Recall Bulletin

PRODUCT SAFETY RECALL

SUBJECT: Shift Lever Indicator May Not Display Correct Gear

The Service Procedure section in this bulletin has been revised to include an inspection to determine if the clam shell has been installed on the transmission shift cable. Please discard all copies of bulletin 12106A.

3256032

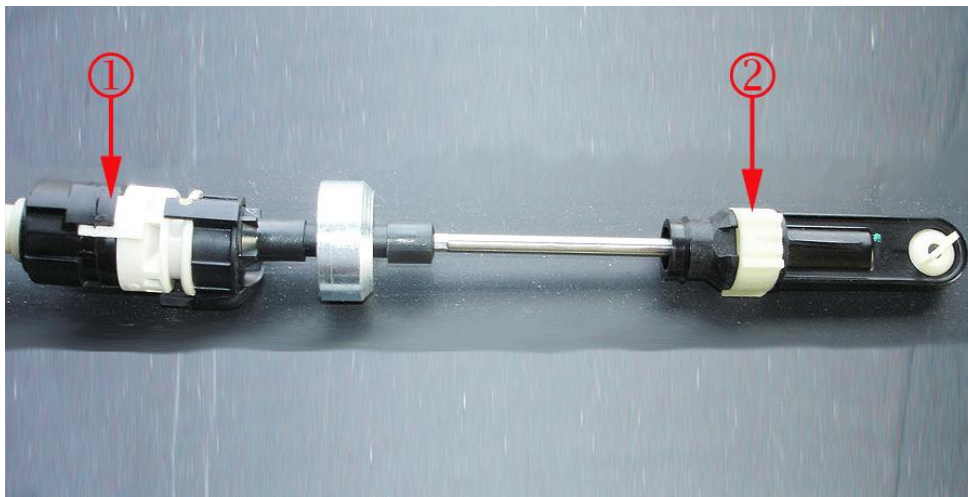
Note: Determine if field action bulletin 09041A has been completed. Inspect the shift cable for the presence of a clam shell cover that surrounds the shift cable locking tabs.

- If the clam shell cover is installed, no further action is required. Refer to the *Warranty Transaction Information* section of this bulletin. Submit a transaction using labor code V2743.
- If the clam shell cover is NOT installed, determine if the transmission shift cable is a first or second design cable.

2269489

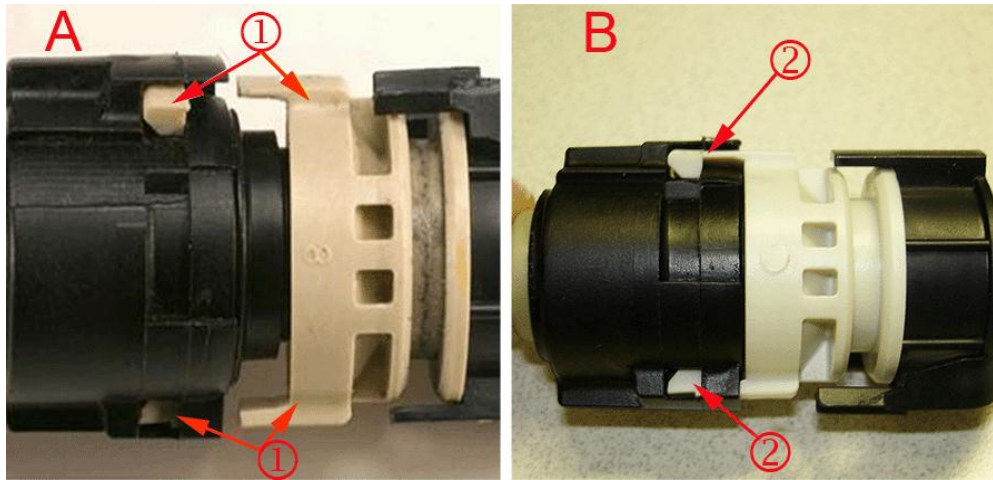
- (1) Shift Cable Locking Tabs
- (2) Shift Cable Adjuster Locking Clip

1. Open the hood and locate the transmission shift cable.

2269486

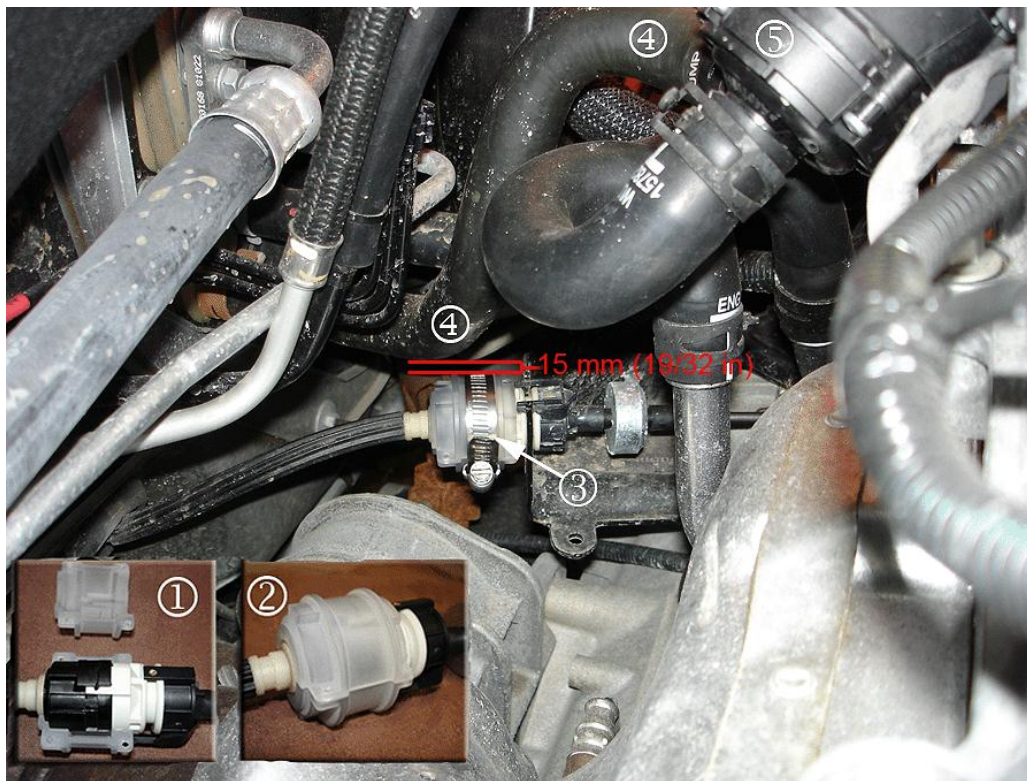
2. Determine if the transmission shift cable locking tabs are fractured and separated.

- If the transmission shift cable locking tabs (1) are fractured and separated (A), remove the transmission shift cable and replace it with a new one. Refer to *Floor Shift Control Cable Replacement or Range Selector Lever Cable Replacement* in SI. **Also install a transmission shift cable kit with the new shift cable.**
- If the transmission shift cable locking tabs (2) are NOT fractured and separated (B), install the transmission shift cable kit. Proceed to Step 3.
